COUNTY OF MIDDLESEX - INTERROGATORY #1

Filed: May 23, 2013
EB-2013-0040 and EB-2013-0041
Exhibit B
Tab 1
Schedule 3
Responses to County of
Middlesex Interrogatories
Appendix A

APPENDIX 'A'

Filed: May 23, 2013
EB-2013-0040 and EB-2013-0041
Exhibit B
Tab 1
Schedule 3
Responses to County of
Middlesex Interrogatories
Appendix B

PLS-CADD Drawing

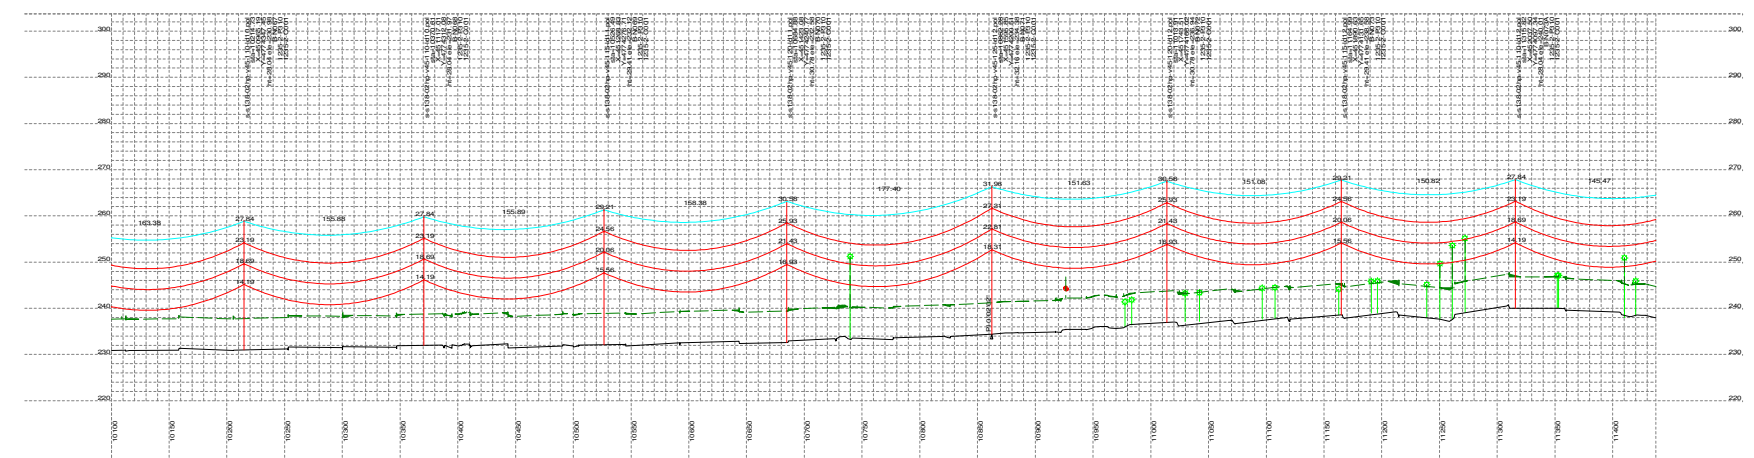
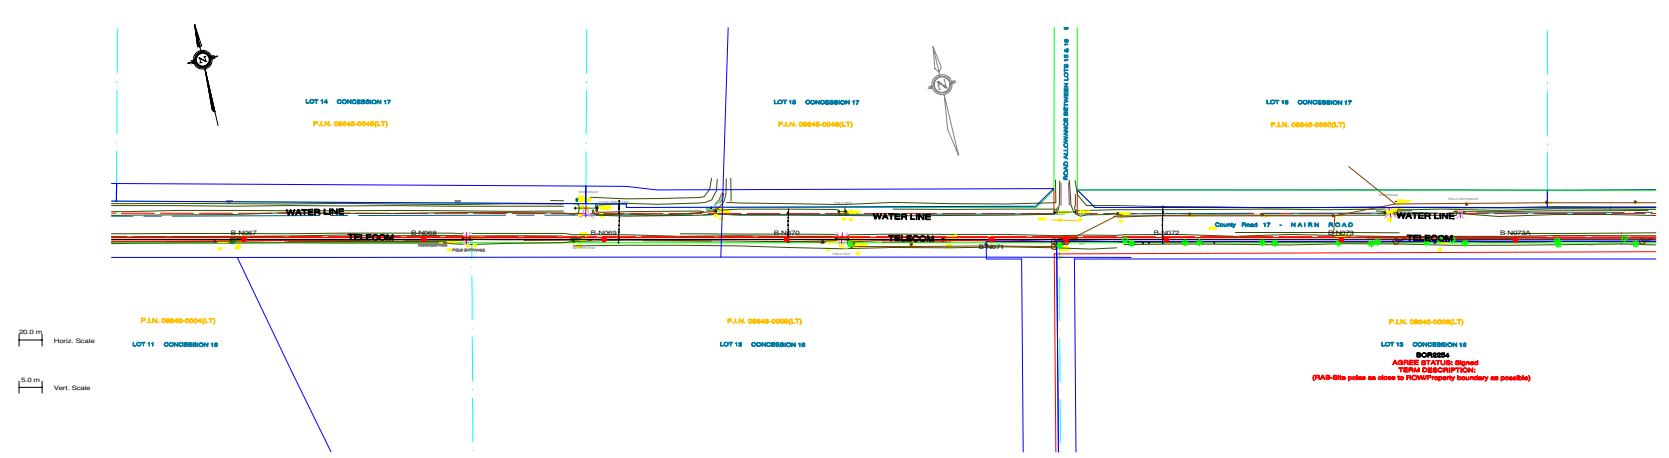
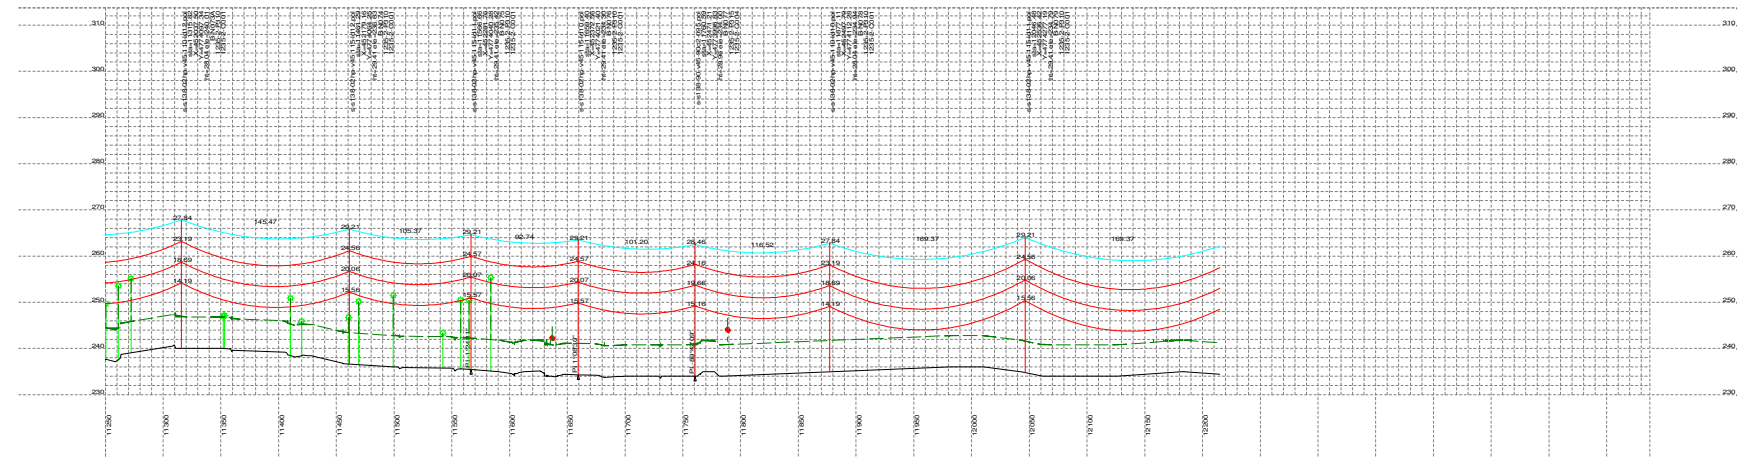
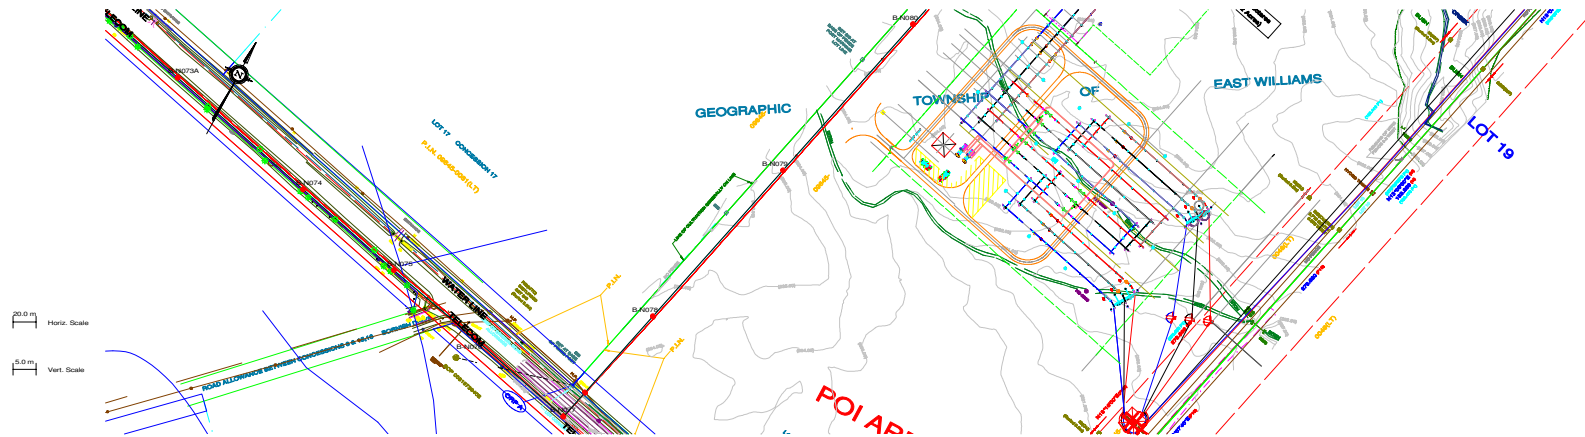
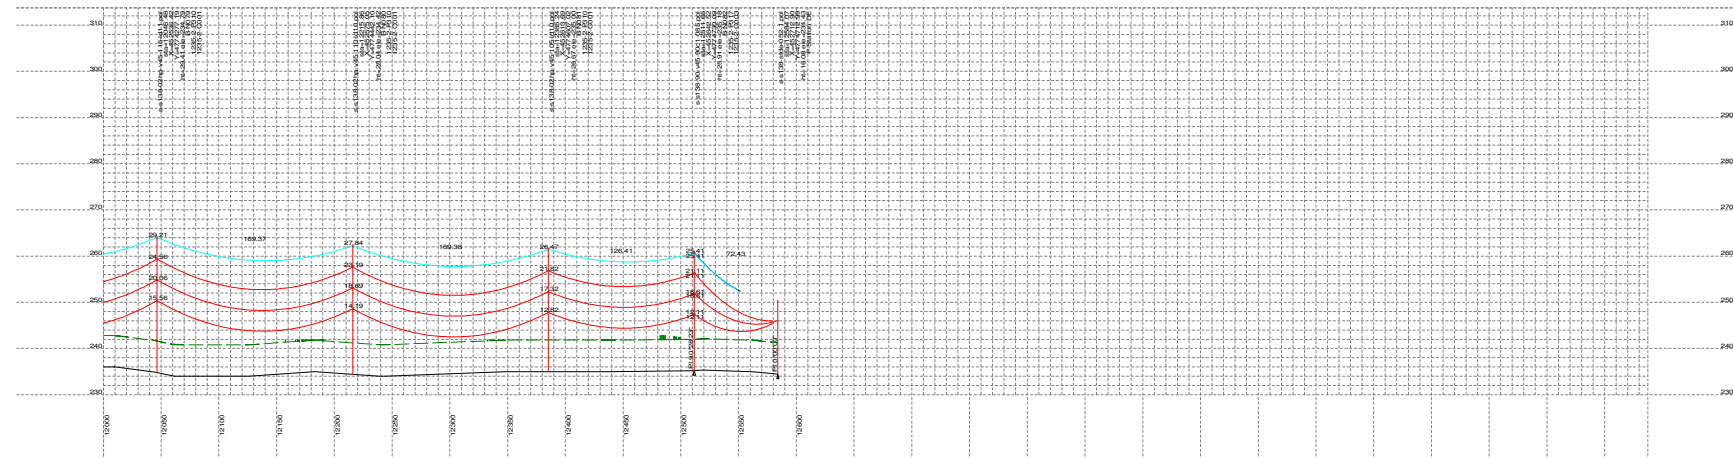
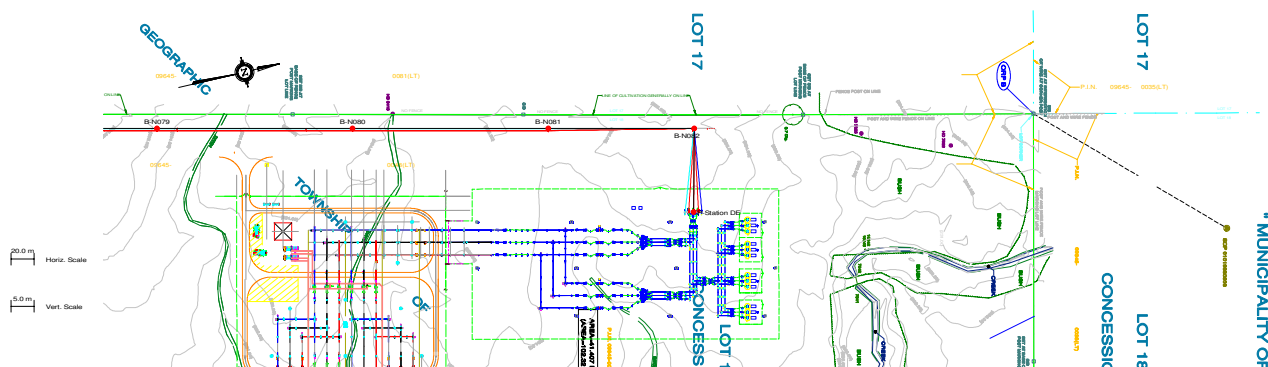
Please provide detailed engineering drawings showing the exact location of all poles and other appurtenances proposed to be located within County road allowances for transmission lines, including all material and construction specifications of poles, wires, guying, foundations, trenching, temporary conditions, and any other items related to this infrastructure.

Please see profile drawings in **Appendix 'A'** in respect of EB-2013-0040 and **Appendix 'B'** in respect of EB-2013-0041 depicting the current design, which is subject to final engineering. Earlier versions of these sets of drawings were provided to the County's Engineer on November 12, 2012. These drawings show the proposed pole, wire and anchor locations. Plans with respect to foundations, materials and construction specifications are not yet finalized. The physical design specifications for the proposed transmission line, including with respect to potential materials, are described in Exhibit D, Tab 1, Schedule 1. In addition, illustrations of potential pole structures and framing designs are provided in Figure 4 of Exhibit B, Tab 2, Schedule 5.
